**Environmental  
Planning  
Commission**

**Agenda Number: 02  
Project Number: 1009414  
Case #: 12EPC -40061  
December 6, 2012**

**Staff Report**

<b>Agent</b>	Mikaela Renz-Whitmore
<b>Applicant</b>	City of Albuquerque
<b>Request(s)</b>	<b>Recommend Adoption of the Volcano Heights Sector Development Plan (SDP)</b>
<b>Legal Description</b>	See attached map
<b>Location</b>	Paseo del Norte on the north and south, Universe Blvd. on the west, Petroglyph National Monument on the east
<b>Size</b>	Approximately 569.11 acres
<b>Existing Zoning</b>	RD, SU-1 PRD FAR. 5, SU-1 C-1 USES
<b>Proposed Zoning</b>	SU-2 VHTC (Town Center), SU-2 VHRC (Regional Center), SU-2 VHVC (Village Center), SU-2 VHMIX (Mixed Use), SU-2 VHNT (Neighborhood Transition), and/or SU-2 VHET (Escarpment Transition)  General Design Regulations are associated to varying degrees with all properties within the Volcano Heights SDP boundary.

Example of a single loaded street in Taylor Ranch adjacent to the Monument

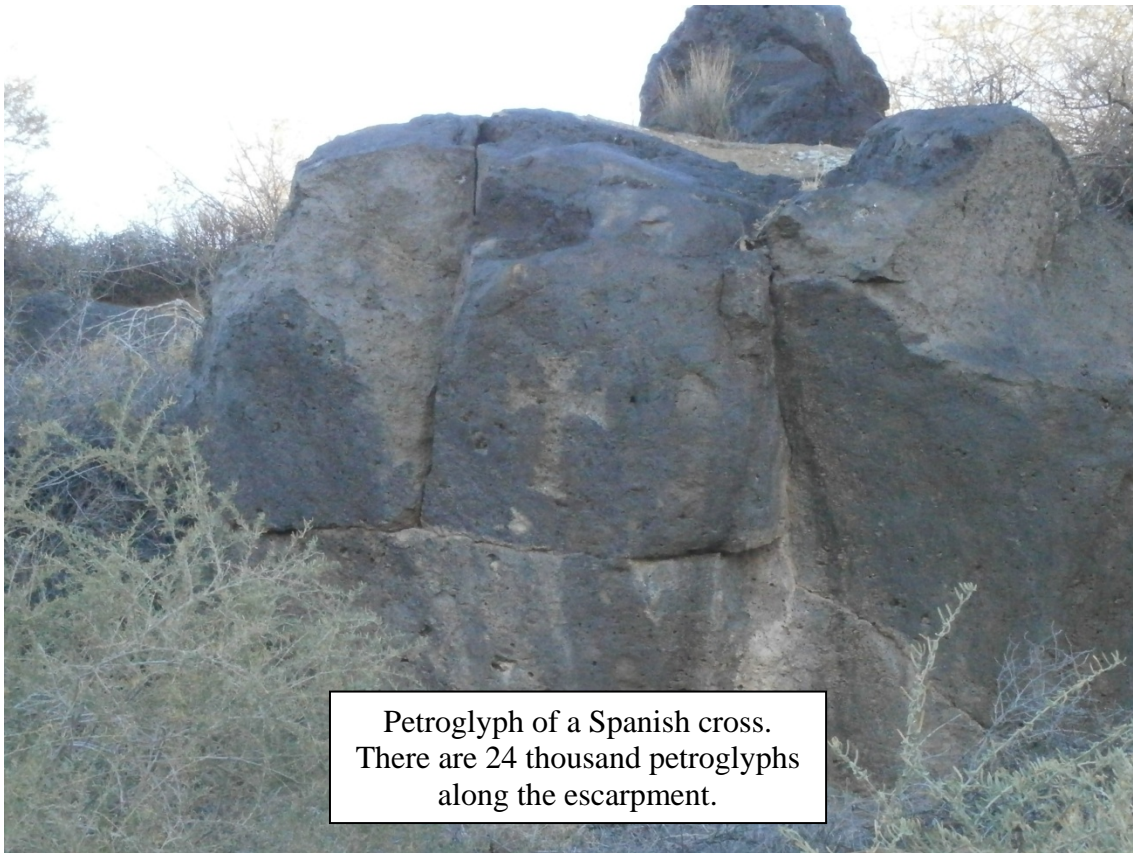
**C) Attached below are photos exhibiting examples of the points made above:**

Exhibit A.41 – Volcano Mesa Area Electrical Facilities Map

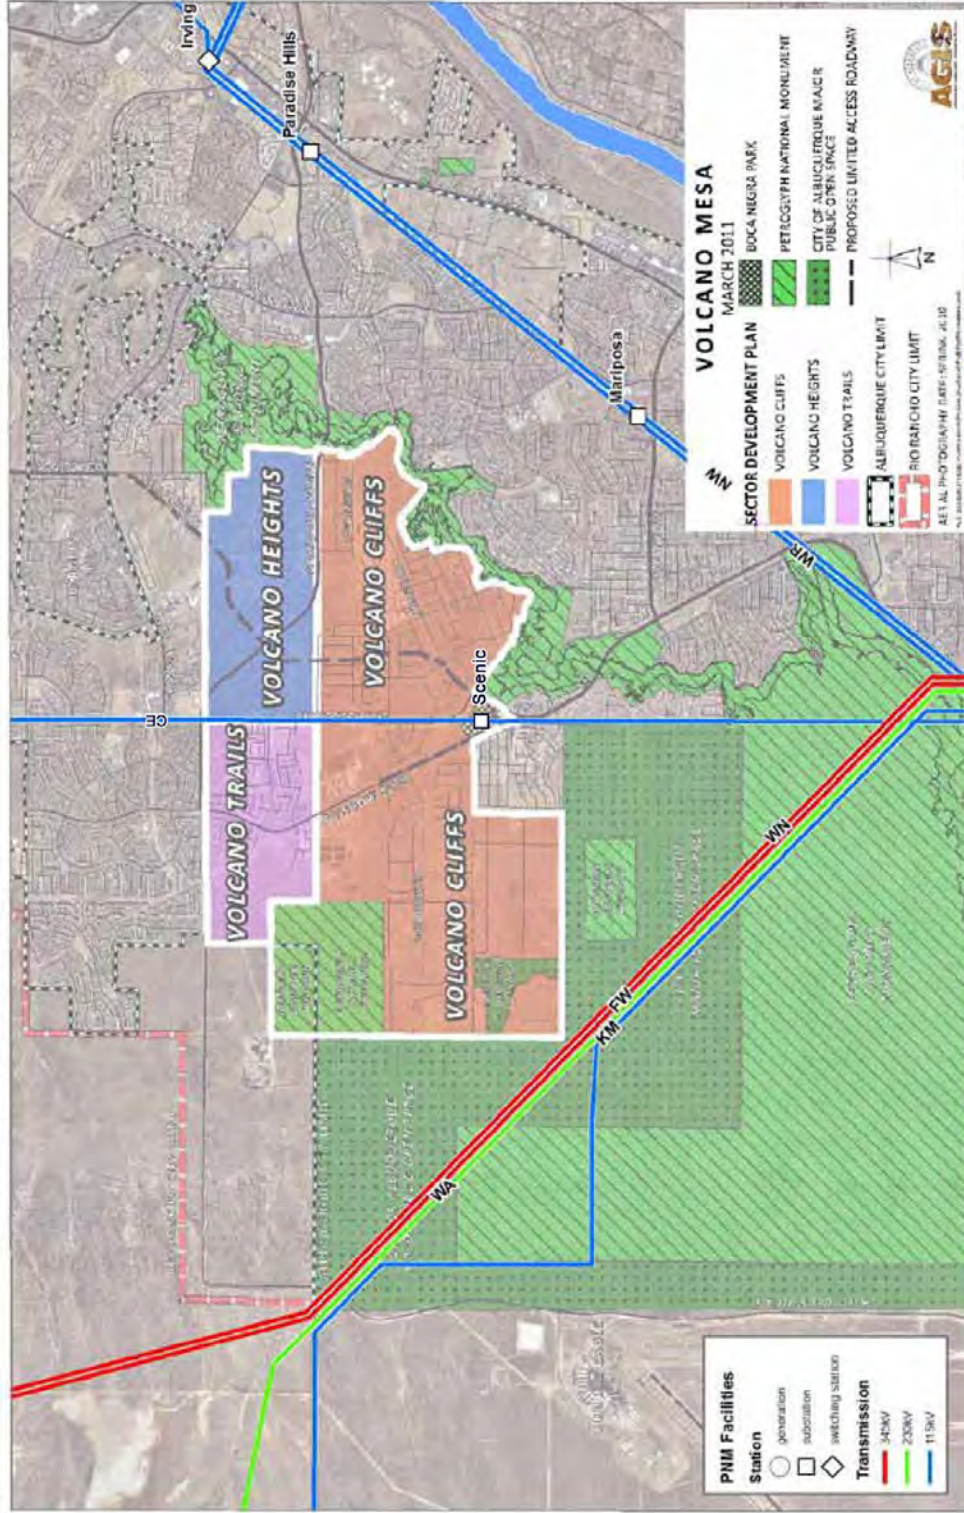
29. New facilities have been approved since the draft Plan’s Exhibit A.41 on page A-38 was created. Please replace Exhibit A.41 in the Plan with the enclosed revised Exhibit A.41 which indicates the location of the approved Scenic Substation under development.

Comment #	Section #	Page #	Comment / Question / Request for Change	No Change (+ explanation)	Change	Condition Language
AC	83	Exhibit A.31	A-38 New facilities have been approved since the draft Plan's Exhibit A.41 on page A-38 was created. Please replace Exhibit A.41 in the Plan with the enclosed revised Exhibit A.41 which indicates the location of the approved Scenic Substation under development.		Staff will replace the exhibit.	On page A-38, update Exhibit A.41.
